UNITED STATES PATENT AND TRADEMARK OFFICE

Office Action Summary

10/685,452

KO, CHIN-SUNG

Lai ('799) Fig. 4

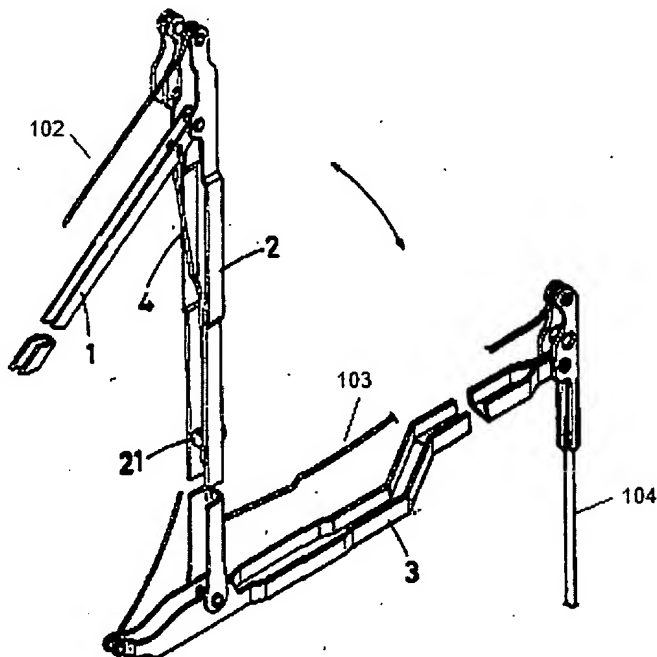
10. Claim 1 is rejected under 35 U.S.C. 102(b) as being clearly anticipated by U.S. Patent 5,392,799 to Lai. Lai ('799) discloses a third rib (3) as being s-shaped.

Lai ('799) discloses a four section structure (1,2,3,104) that contains upwards of 8 ribs (1,2,3,4,102,103,104).

Shih-Shin 2002/0112750 Fig. 2

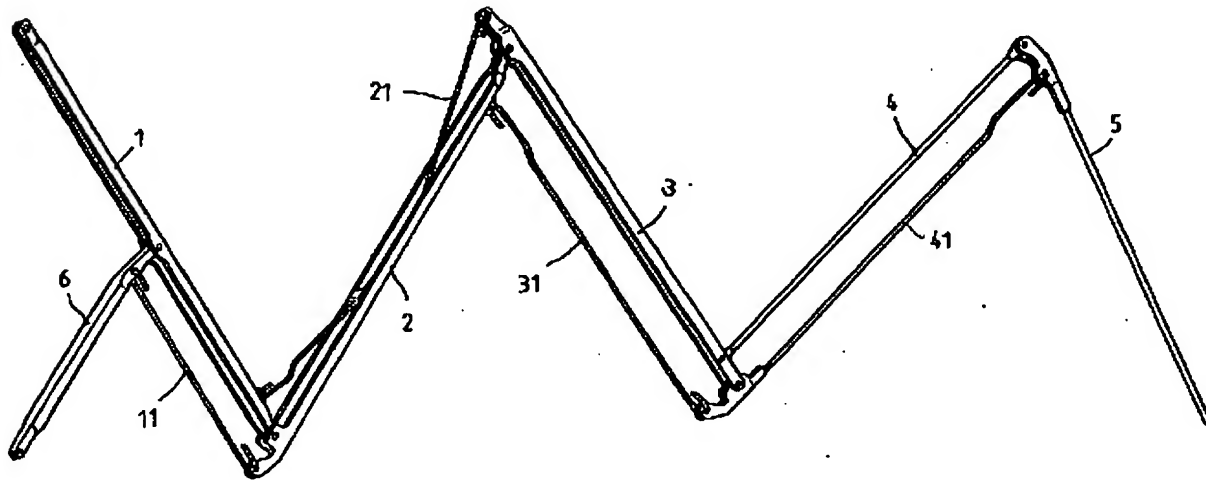
11. Claims 1 and 2 are rejected under 35 U.S.C. 102(b) as being clearly anticipated by U.S. Patent Publication 2002/0112750 to Shih-Shin. Shih-Shin discloses a five-folded umbrella frame. A third rib member (3) has upper end with a bent part that attaches to member (2). A fourth rib member (41) has a bent end where it attaches to member (3). The bent member of (3) and (41) reverse directions.
